XDPL8221 errata sheet

XDPTM Digital Power

This errata sheet lists the known issues of [XDPL8221](#) digital PFC + flyback controller IC with the firmware version 1.0.0.

Figure 1 Required Additional Idle Time after the First Byte

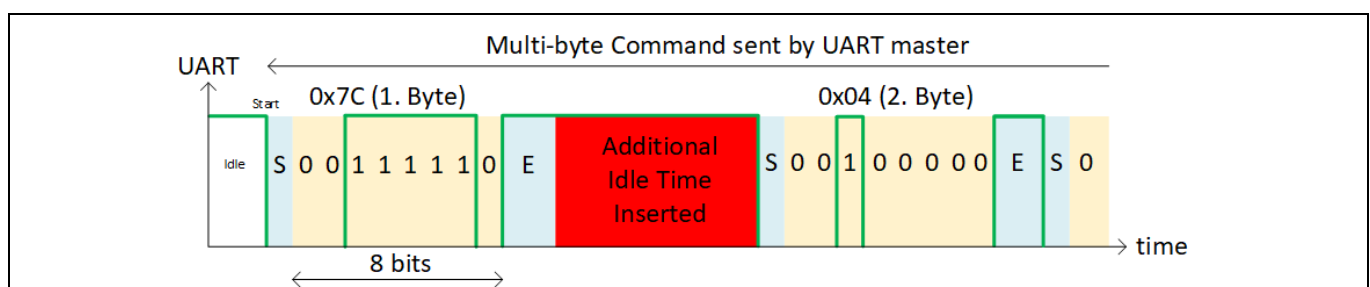
XDPL8221 with firmware version 1.0.0 will not answer with ACK (0x00) to a UART command independent of the operation code. The communication fails and does not recover. It can be re-established through a new V_{CC} power cycle (XDPL8221 V_{CC} voltage must first be discharged under off-threshold and then charged to exceed on-threshold).

XDPL8221 changes its originally fixed (slave) baud rate 57.600 baud beyond +/- 6.25% (allowed tolerance range) by mistake due to the occasional mistracking of UART (master) baudrate. This wrong UART transmission speed of XDPL8221 leads to communication stop.

To avoid XDPL8221 mistracking of UART (master) baudrate, a recommended additional idle time of 100us must be inserted between the first and the second byte of a multi-byte command sent by UART master as illustrated in the **Figure 1** below.
